COMMITTEE OF THE WHOLE MAY 2, 2005

**ZONING BY-LAW AMENDMENT FILE Z.03.104
SITE DEVELOPMENT FILE DA.03.080
VALENTINA AND VLADIMIR KRCDMAR
REPORT # P.2004.34**

Proposed Site Plan

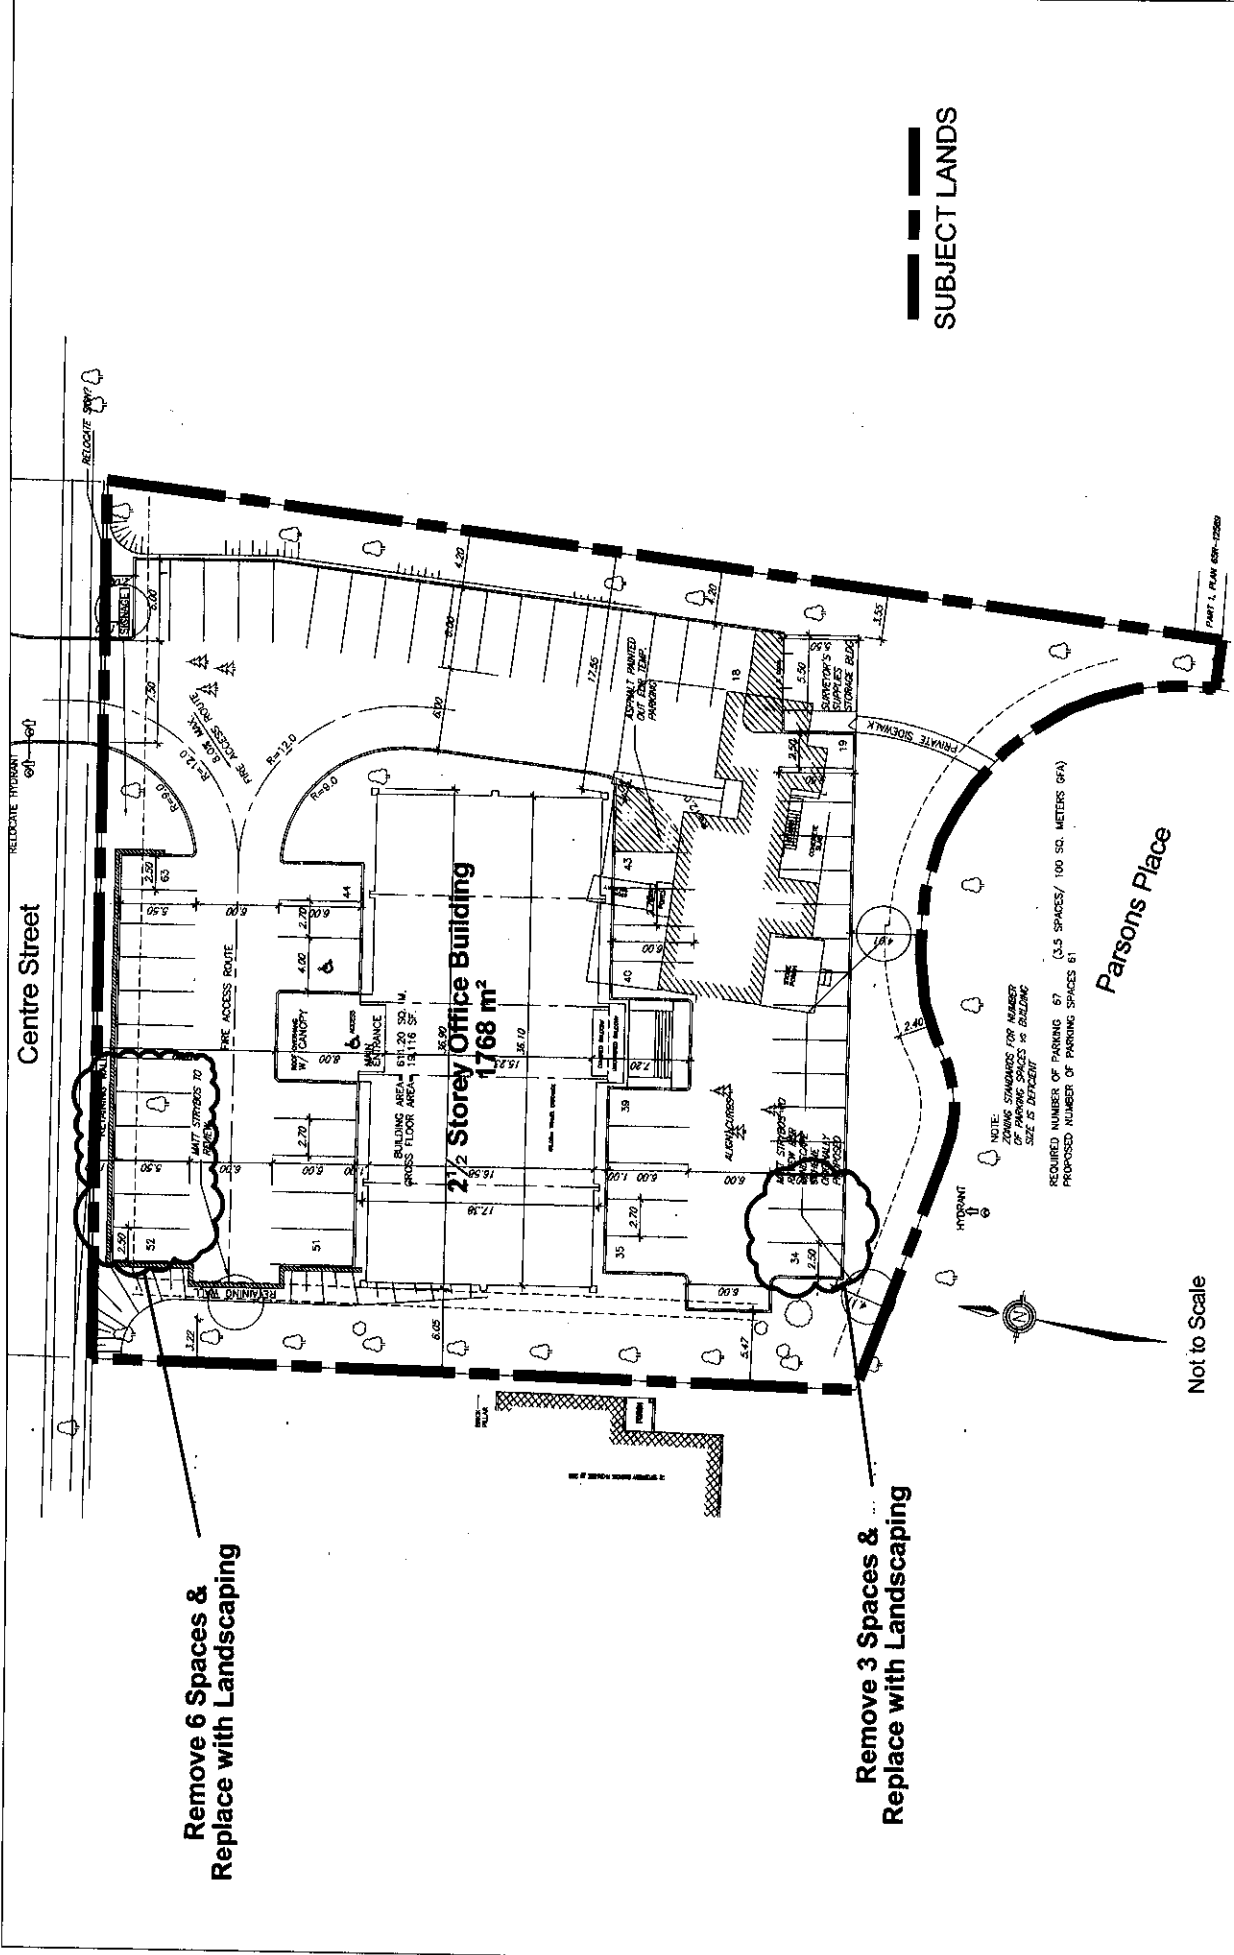
Attachment #2 proposes the building location at the northwest corner of the subject lands having a street presence along Centre Street. The only access to the site is from Centre Street leading to a reversed L-shaped parking area. Parking has been provided to the east and south of the building. An accessory building used for storage and refuse is located at the southeast corner of the subject lands. Landscaping has been provided around the periphery of the site, with an effort to maintain the existing mature landscaping.

On this basis, Staff cannot support the applicant's proposed site plan as shown on Attachment #2. It is recommended that the Committee not support the applicant's site plan, and that instead, the Committee endorse the City's red-lined site plan as shown on Attachment #3, for approval by the Ontario Municipal Board.

- All access to the site will from Centre Street and is subject to the approval of the Region of York Transportation and Works Department;
- The proposed building location as shown on Attachment #2 is not compatible with the residential character of the surrounding area, in respect to the landscaping, buffering and building setbacks;

- The location of the building as proposed on Attachment #2, is not in keeping with the building setbacks of the residential properties flanking the subject lands to the east and west. Residential lots to the west are zoned R4 Residential Zone fronting on Parsons Place with rear yards abutting Centre Street. The residential lots to the east are zoned R3 Residential Zone. The R3 and R4 Zones require a minimum rear yard of 7.5m in comparison to the office building's proposed minimum 3.0m setback from Centre Street. The variation in setbacks from Centre Street creates a significant visual difference and inconsistency between the location of the proposed office building and the existing residential. This variation in setbacks would also interfere with the sight lines of the adjacent residents and impacts upon the privacy and enjoyment of the rear amenity areas of the adjacent residents;

The Development Planning Department's preferred plan (see Attachment #3 – City of Vaughan red-lined plan) shows the building with a slightly reduced gross floor area of 1,768m² located centrally to the site. The proposed parking area forms a U-shape around the building. The centrally located building is in keeping with the location of the residential dwellings on the adjacent lots to the east and the west. Landscaping is being provided around the periphery of the site, and will maintain the existing vegetation. Trees will also be relocated and replanted on the site. Access to the site is only from Centre Street. The accessory building has been reduced in size, and is located at the southeast corner of the subject lands.

City of Vaughan Red-Lined Site Plan

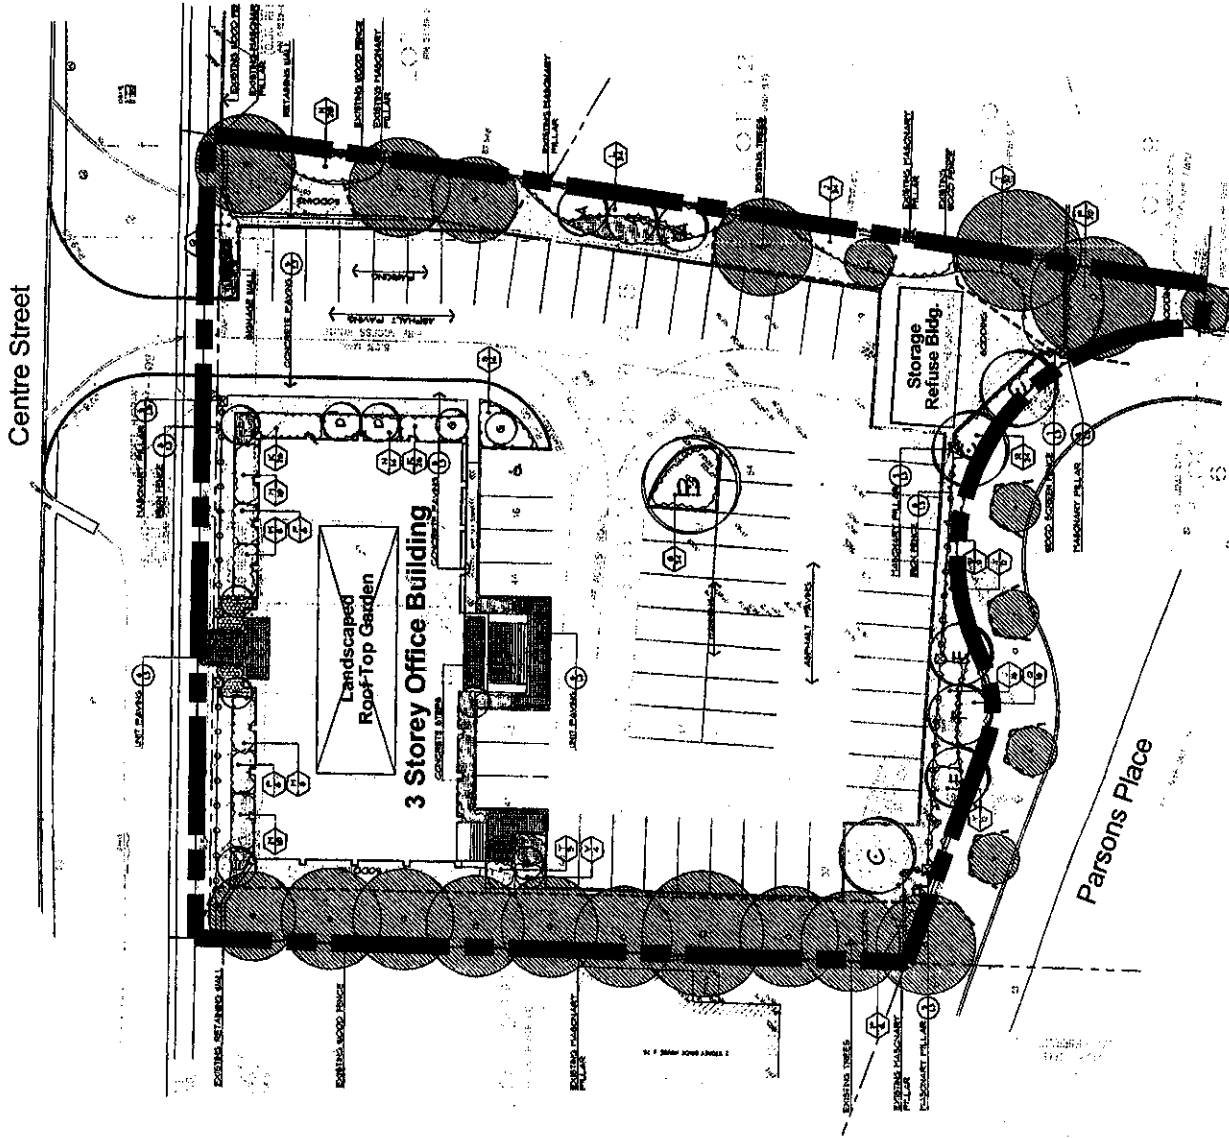
The revised proposal as shown on Attachment #3, which City Staff is in support of would require all the same exceptions identified above, except for the reduction to the minimum front yard. As shown on Attachment #3, relocating the building to a central location on the subject lands would comply with the minimum 9.0m front yard requirement. In addition, an exception for a reduced landscape strip width of 1.5m along Centre Street will be necessary, in light of the grading issues, which will require a retaining wall to be constructed. As discussed in the "Landscaping" section of this report, 6 of 12 parking spaces along Centre Street as shown on the City's red-line plan (Attachment #3) will be removed, and replaced with landscaping.

Although the revised proposal indicates 63 parking spaces, Staff would support a minor reduction in parking as shown on Attachment #3 (City of Vaughan red-lined plan), to replace the parking spaces in the northwest and southwest parking areas with additional landscaping, thereby further mitigating the concerns of the neighbouring residents. A reduction in parking to 54 spaces (13% deficiency) can be supported, as discussed in the "Parking" section of this report.

The City of Vaughan's red-lined plan provides 63 parking spaces, with a surplus of 1 space. However, Staff have concerns respecting the reduction to the required landscaping strip width along the southerly lot line and would support the removal of 3 parking spaces in order to provide an increased coniferous landscaped buffer at the southwest corner of the subject lands abutting the rear (southerly) lot line (see Attachment #3).

As identified earlier in the "Zoning" section of this report, there is a retaining wall that is required to be constructed along the frontage of Centre Street, which limits the landscaping strip width to 1.5m. Accordingly, in order to increase the amount of landscaping along Centre Street, but still ensure that there is sufficient parking to serve the development, 6 of 12 parking spaces along Centre Street will be eliminated and replaced with landscaping and also to preserve a mature tree, as shown on Attachment #3.

The removal of 9 parking spaces to be replaced with landscaping, would yield a revised parking total of 54 spaces (13% deficiency), which can be supported by Staff, in order to achieve a more appropriate and compatible site plan layout that can be integrated with the surrounding residential development. However, this will need to be confirmed through the submission of a parking report, to be reviewed to the satisfaction of the Engineering Department.

The parking space depths that are shown at 5.5m, will be increased to a minimum of 6m, in keeping with the requirements of By-law 1-88. This can be achieved when the red-lined site plan is redrawn to show a smaller foot-print.

Staff has provided a more appropriate alternative to the applicant's proposed submission, taking into consideration the surrounding residential context of the area. The City of Vaughan's Red-lined Plan (see Attachment #3) provides a site plan layout that is sensitive to the surrounding residential development, provides as much landscaping as possible, and preserves existing mature trees around the periphery of the site. The Red-lined plan also proposes a slightly smaller building GFA and smaller accessory building. The City's recommended plan would meet all of the site design criteria in the Official Plan. On this note, the City's red-lined site plan, landscape plan and building elevations shown on Attachment #3, #5 and #7, respectively, should be endorsed for approval by the Ontario Municipal Board (OMB). Accordingly, the recommended

Proposed Landscape Plan

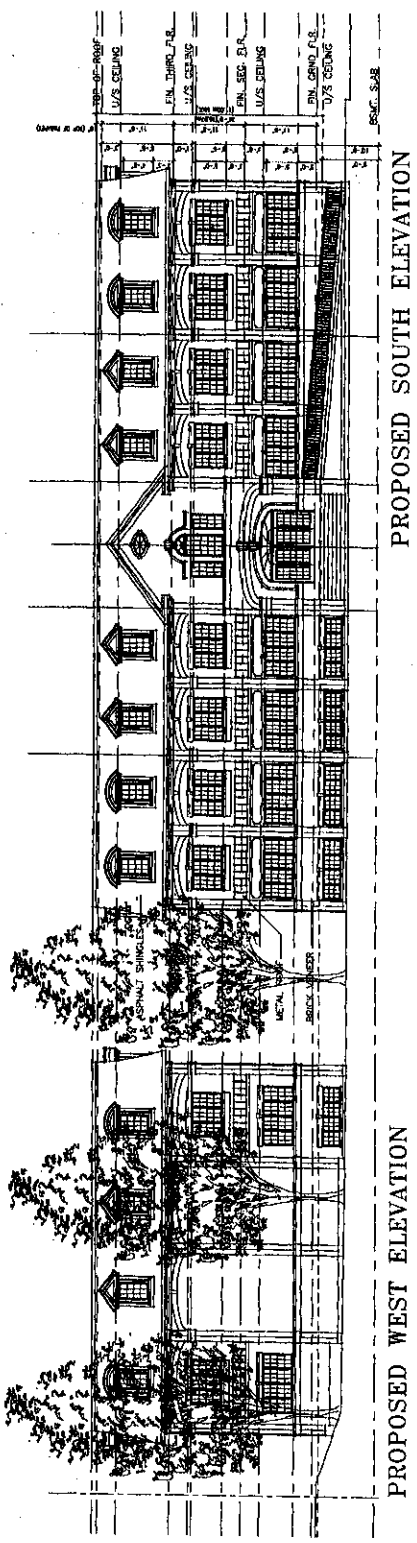
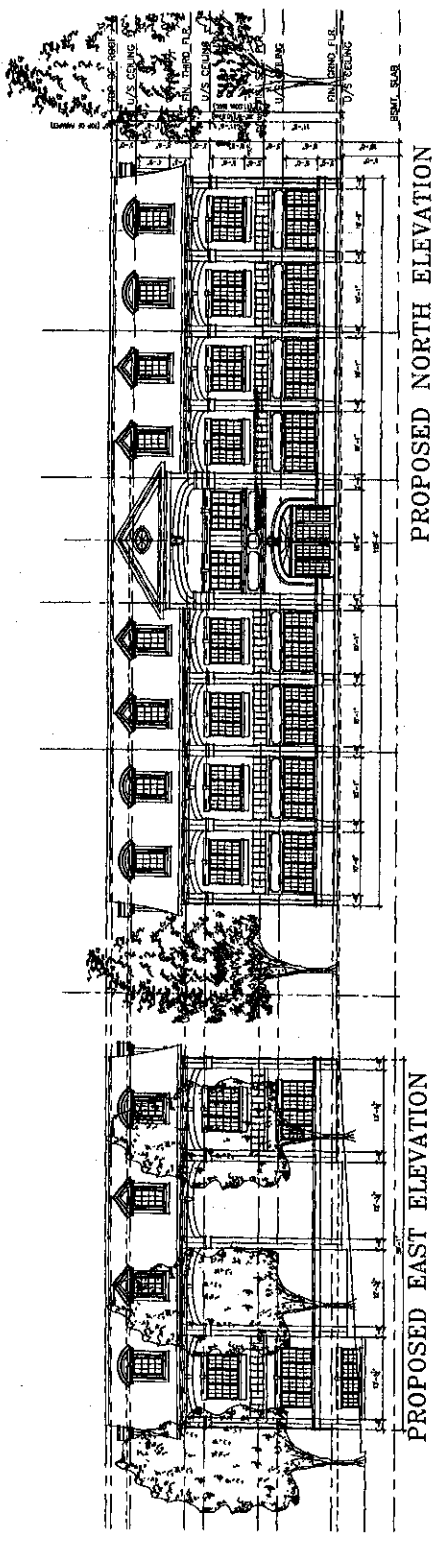
The applicant is proposing to maintain as much existing landscaping on site as possible, except in the rear yard, which will be paved with a hard surface to facilitate parking, as shown on the Applicant's landscape plan (Attachment #4). A mix of deciduous and coniferous tree and shrub

On this basis, Staff cannot support the applicant's proposed landscape plan as shown on Attachment #4. It is recommended that the Committee not support the applicant's landscape plan, and that instead, the Committee endorse the City's red-lined landscape plan as shown on Attachment #5, for approval by the Ontario Municipal Board.

The City of Vaughan's Red-lined Landscape Plan (see Attachment #5) also proposes a mix of coniferous and deciduous tree and shrub planting, as well as, preserving additional existing mature trees on site, including along Centre Street. Special attention to the planting along the rear lot line abutting Parsons Place is also proposed. Due to the relocation of the building, planting is proposed along the north, south and east elevations. A pedestrian walkway with an iron gate leading from Parsons Place to the subject lands has been incorporated into the site and landscape design.

The City will also allow planting to be provided in the City of Vaughan's boulevard along Parsons Place in an attempt to create an additional layer of landscape screening. The proposed trees and shrubs to be planted in the boulevard are to be maintained by the applicant, at their cost, including watering, feeding and pruning, and will be included as a condition of the site plan agreement. City Staff also require that pedestrian scale lighting poles be used within the parking areas.

Proposed Building Elevations

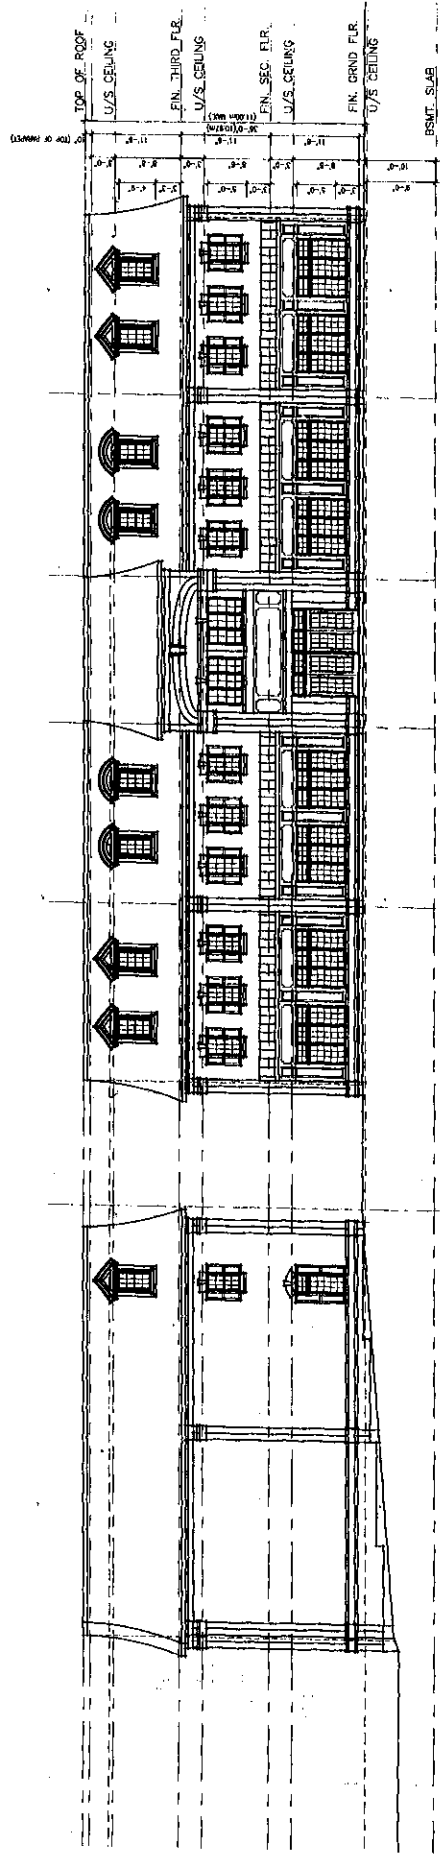
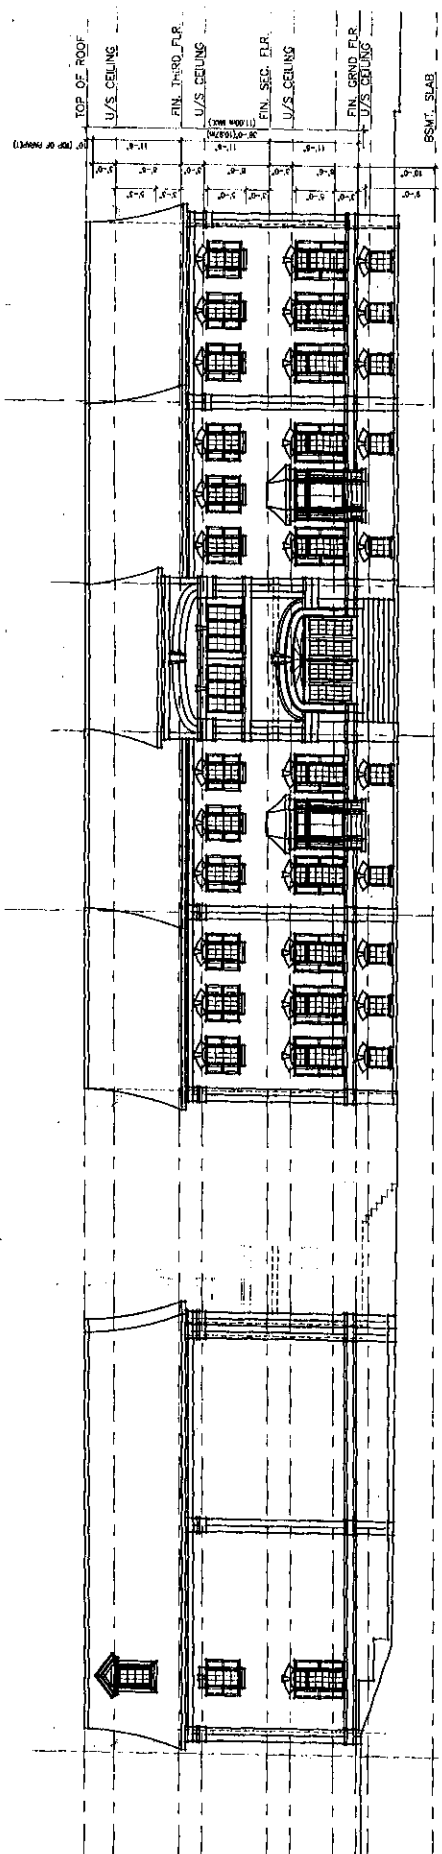
The applicant's proposed elevation (see Attachment #6) has two main entrances on each of the north and south elevations. The main entrance on the north elevation is centrally located and covered by a canopy two storeys in height and supported by two columns. A single storey canopy covers the main entrance on the south elevation. Due to the site layout as shown on Attachment #2, the building is located at a higher elevation, requiring exterior stairs and a ramp to access the entrance on the south elevation. Four rows of windows have been provided on each side of the entrances for both the north and south elevations. Window dormers have also been provided in the roofline of the building.

On this basis, Staff cannot support the applicant's proposed building elevations as shown on Attachment #6. It is recommended that the Committee not support the applicant's building elevations, and that instead, the Committee endorse the City's red-lined elevation plan as shown on Attachment #7, for approval by the Ontario Municipal Board.

The City of Vaughan Red-lined Plan as shown on Attachment #7 differs slightly in that the window treatments are not as symmetrical. The north elevation proposes smaller windows for the second

storey with wood shutters creating a residential look to the building. The south elevation has also incorporated residential design elements including shutters for the windows on the first and second storey, as well as, a bay window on each side of the main entrance.
